SERVICE BULLETIN

APPLICABILITY: 2019MY Ascent

NUMBER: 12-258-19

SUBJECT: Rear Combination Lamp Access Panel Retaining Clips

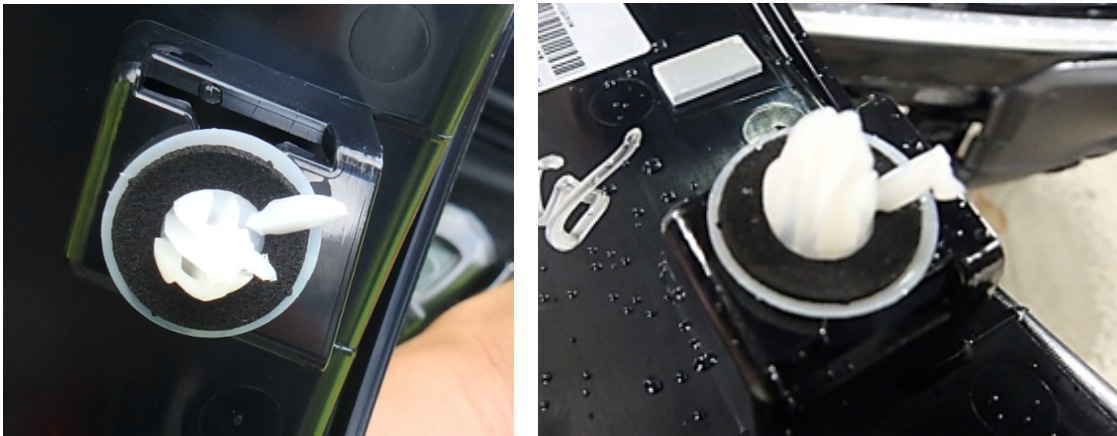
The photos below show damaged clips identified during inspection for a concern of water accumulating in the spare tire well area. Damaged portions of the clip have compromised the sealing portion and caused the leak.

REMINDER: Customer satisfaction and retention starts with performing quality repairs. The basic service procedures for removing and installing the tail lamp access covers have been changed. **This change involves the two retaining clips which are now ONE-TIME USE items and MUST always be replaced before reinstalling the tail lamp access covers.** Always refer to the applicable Service Manual and review the full requirements of the repair being performed. This includes SAFETY precautions, proper inspection criteria, special tools, required processes and related one-time-use parts needed for a complete and lasting repair.
